DESCRIPTIVE REPORT

Type of Survey Hydrographic
Field No. RA-5-1-98
Registry No. H-10798

State Washington
General Locality Seattle Harbor
Sublocality Elliott Bay

EVALUATION REPORT

Chart 18450 15th ED

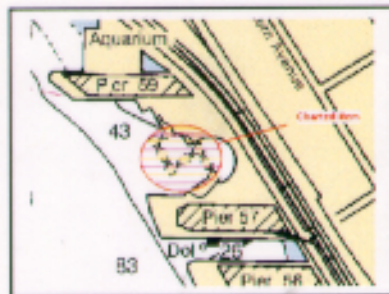
The charted structure at approximately latitude 47/36/23.76N and longitude 122/20/31.92W is no longer visible. The source for this item should be investigated. The evaluator recommends removing this feature from the chart if the construction plans and or as-built drawings were not completed according to the original drawings. In the interim, this structure is recommended to be charted as submerged. See the figures below.

Chart 18450 15th Ed., May 16, 1998

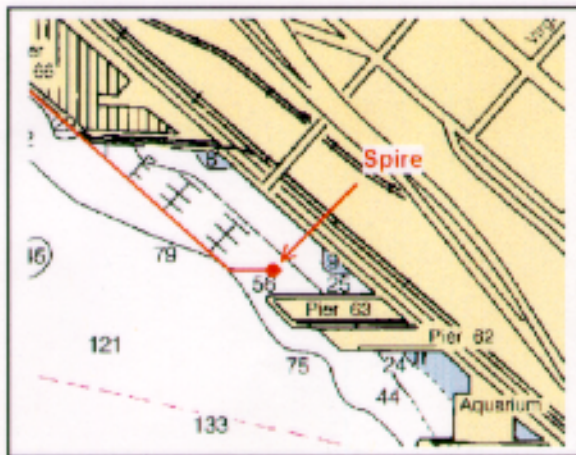
There was one private floating aid located within the survey area. It is an amber light attached to a fish pen at latitude 47/37/20.65N and longitude 122/22/05.06W. The current charted position on chart 18450 15th Ed., May 16, 1998 is incorrect. The light should be charted according to this survey. See below.

There were no landmarks located and or verified within the area of this survey. The evaluator recommends retaining all landmarks as charted. One new feature (spire) located on the new breakwater for the Bell Street Pier Marina (Pier 66) is recommended to be charted as a new landmark. The approximate location is latitude 47/36/32.76N and longitude 122/20/46.32W. It has a height of 158 feet. This landmark is very important for small boaters trying to locate the entrance to the marina. The approximate location on chart 18450 and a photo is below. A description of this feature is attached to this report. It is recommended that a photogrammetric position be obtained for this feature.
